EVALUATION OF DOD WASTE SITE GROUNDWATER
PUMP-AND-TREAT OPERATIONS

Report Number 98-090

SUBJECT: Evaluation Report on DoD Waste Site Groundwater Pump-and-Treat
Operations (Report No. 98-090)

**Figure 1: Number Of Pump-And-Treat Systems
Becoming Operational By Year (75 of 78)**

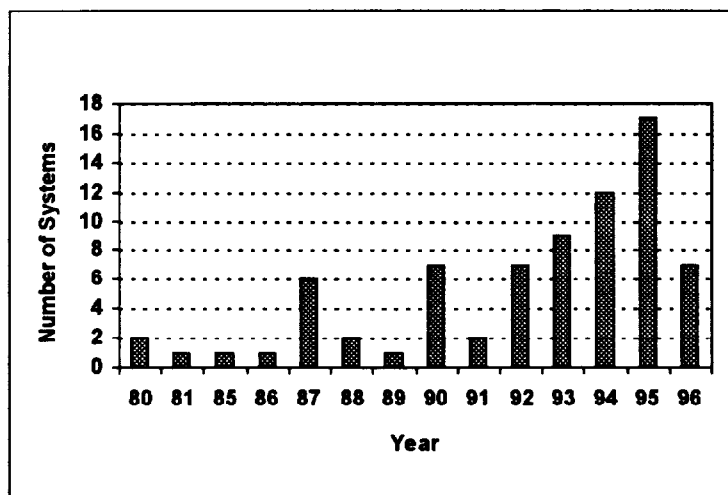
j. Page 6, Figure 1. The report should note that permeable reaction walls (PRWs) using zero-valent iron were first applied in the 1995-1996 time frame. PRWs are probably the most promising technology for removal of chlorinated solvents such as TCE in shallow ground water. Note that the number of pump and treat systems put into operation in 1996 is significantly lower than in 1995, perhaps an indication of the more widespread acceptance of alternative technologies in the mid-1990's.

On page 5 of the Draft Evaluation Report, "DoD Pump-and-Treat Systems," in regard to sentence three of the first paragraph, Figure 1 should read "Figure 1 shows the number of systems becoming operational each year." Figure 1 does not demonstrate that few systems are being turned off as currently stated.

Figure 2: Total Annual Operations and Maintenance Plus Monitoring Costs

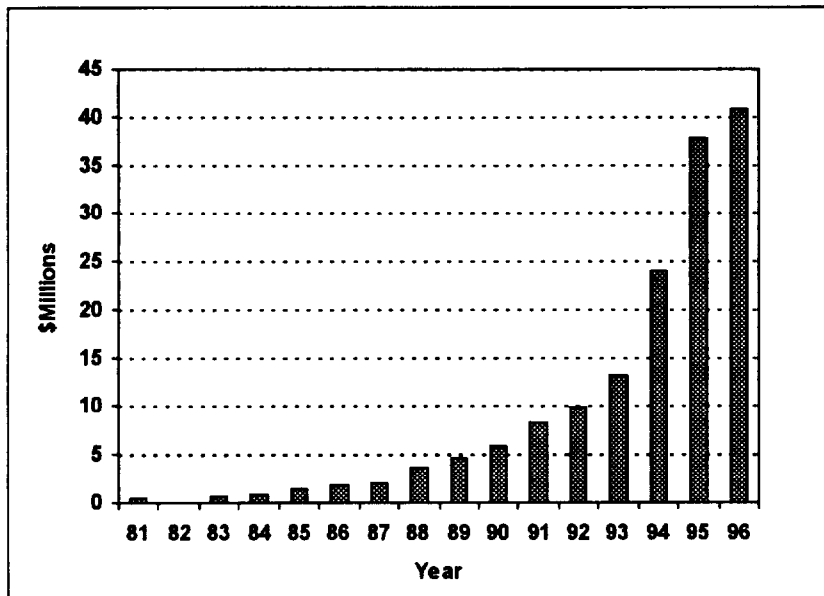
r. Page 10, first paragraph, last sentence. The conclusion reached in this sentence does not necessarily follow from the figure below it. The total costs presented in Figure 2 are a function of the total number of systems in operation. Much of the increase in O&M costs after 1994 is the result of 24 additional systems being brought online in 1995 and 1996. Therefore it is misleading to imply that O&M costs will continue to increase at the same rate as that shown in the figure when the number of new pump and treat systems is declining (only 7 systems brought online in 1996 compared to 17 systems in 1995).

Figure 3: The Year Each System Became Operational Versus The Estimated Operation Life Of The System

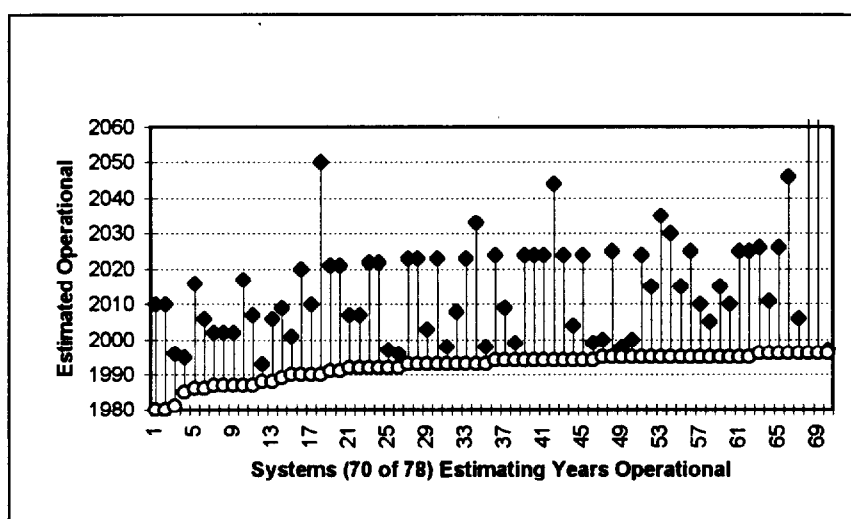
18. page 10, para 2, last sentence, last line. Replace "to attain its cleanup goals" with "to attain its goals." Add another sentence, "Project life could also be less if MCLs increase or natural attenuation proceeds more rapidly than expected."	Revised
